# Design Review Panel Response Statement

41 Beach Road

July 2023

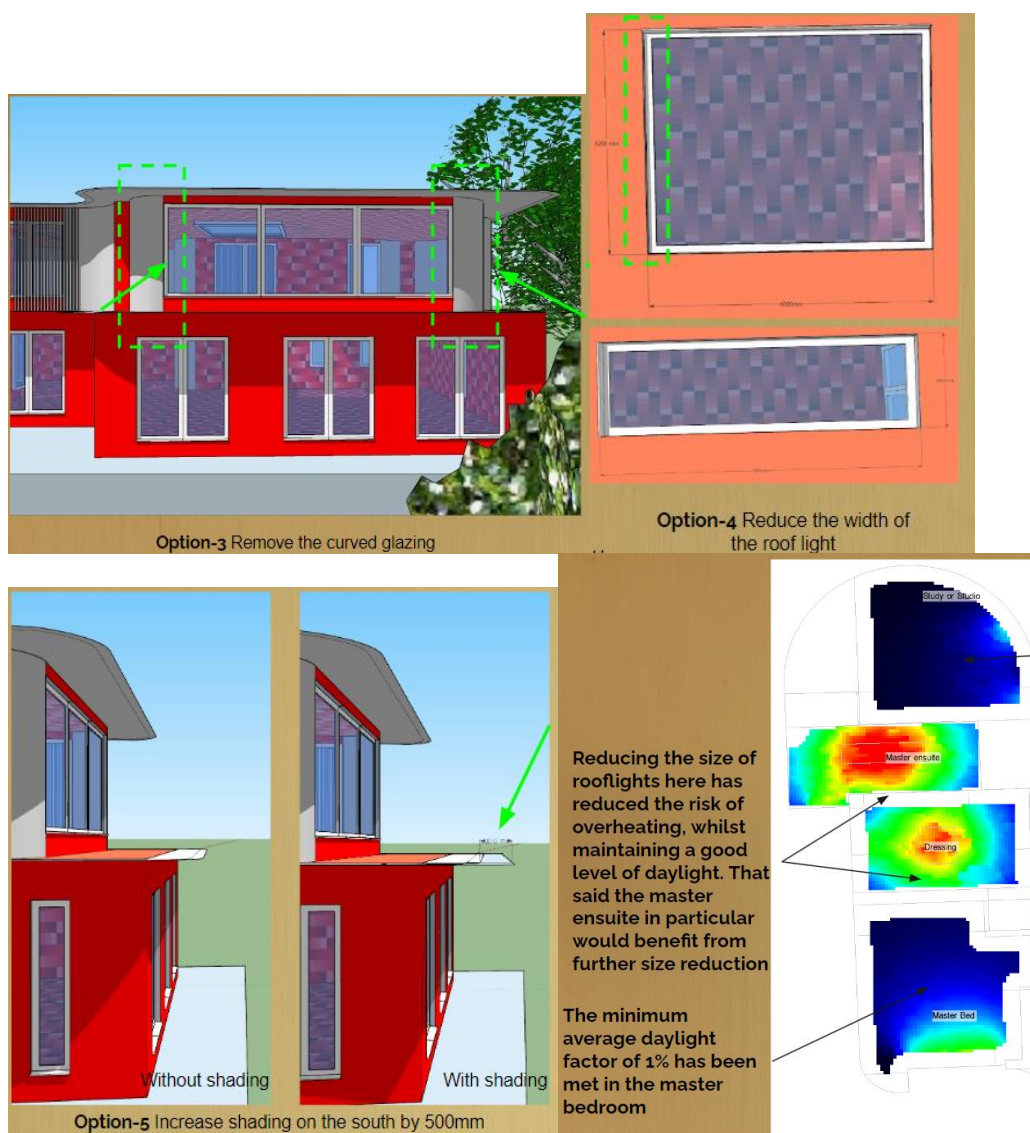
3.3. "The analysis addresses solar gain in relation to Passivhaus, however, this approach might be considered out of context and could benefit from a more comprehensive discussion. Evidence of design development beyond the single concept design presented may also enhance the understanding of the project's progression."

3.3.1. The following statement has been extracted from the SS:

**"Daylight Optimisation** - Glazing is typically both 6 times worse performing per  $m^2$  of opaque fabric and 6 times more expensive. It also acts as the primary cause of overheating. Each of these negative characteristics need optimising against daylighting and framing principal views. Design Builder Dynamic Simulation Model (DSM) is capable of optimising the building on a room by room basis enabling the design team to minimise the glazing proportion whilst satisfying the RIBA standards for daylighting. The inherent massing design of the proposed dwelling aims to take advantage of passive solar gains in the colder months whilst reducing overheating potential through the adoption of solar shading optimised using PHPP and Design Builder DSM with specifically designed window reveals and roof overhang."

3.3.2. The design development went through multiple iterations and only a single concept was chosen as an example in the SS in interests of brevity. To aid understanding of the design progression further evidence of options consider to find a balance between daylight and excessive summer solar gains is shown below:

*Fig. 13: Schöck Isokorb® T type SK: Insulating element inside the core insulation; stub bracket between the Isokorb® and the balcony to enable flexible installation.*

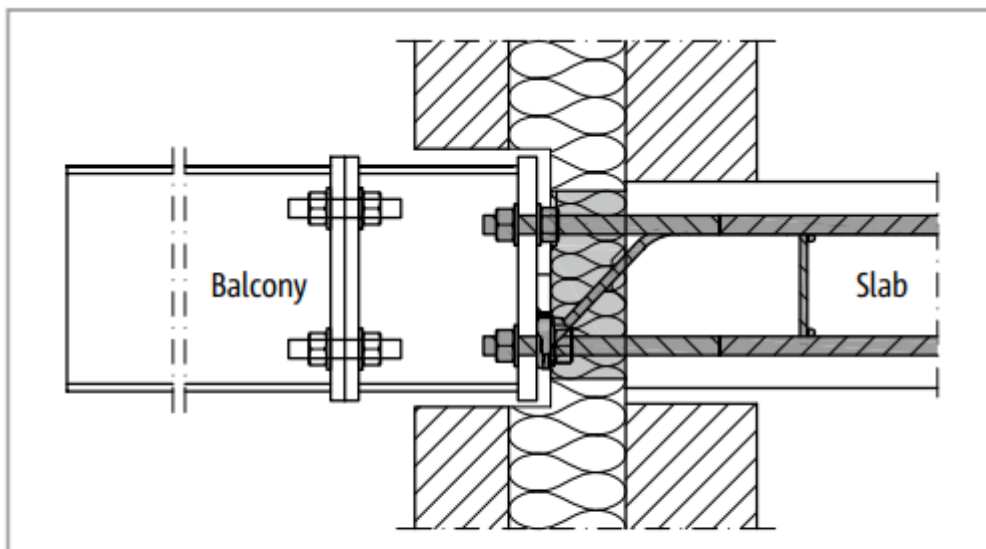
3.4. "It is currently unclear how the continuous junction around the floor and roof slab will achieve the stringent thermal bridge requirements of passive house standards, especially given the proposed steel construction, which is to be clad in concrete on the outside. It is suggested that Passive House standards are unlikely to be achieved with a continuous thermal bridge as designed, and the sustainability statement seems to brush over this point rather than address it in any robust manner: "Thermal bridge reduced design - Defined by the Passivhaus institute as having no installation psi value exceeding  $0.01 \text{ W/m}^2\text{K}$ . This is very difficult to achieve in practice, yet our initial THERM modelling demonstrates that this is possible for all opaque elements of the building." This is not to say that the proposal is not highly sustainable, but passive house is likely to be tricky unless a thermal bridge junction can be designed and included within the PHPP."

3.4.4. When working with PassivHaus projects that have continuous junctions associated with balconies and steel to steel connection across the thermal envelope, Ecospheric typically specifies a number of thermal break components from companies such as Farrat and Schöck. The following are typical details that are specified and the associated Psi/Chi values that can comfortably work within the PassivHaus certification criteria:

3.4.4.2. Schöck Isokorb
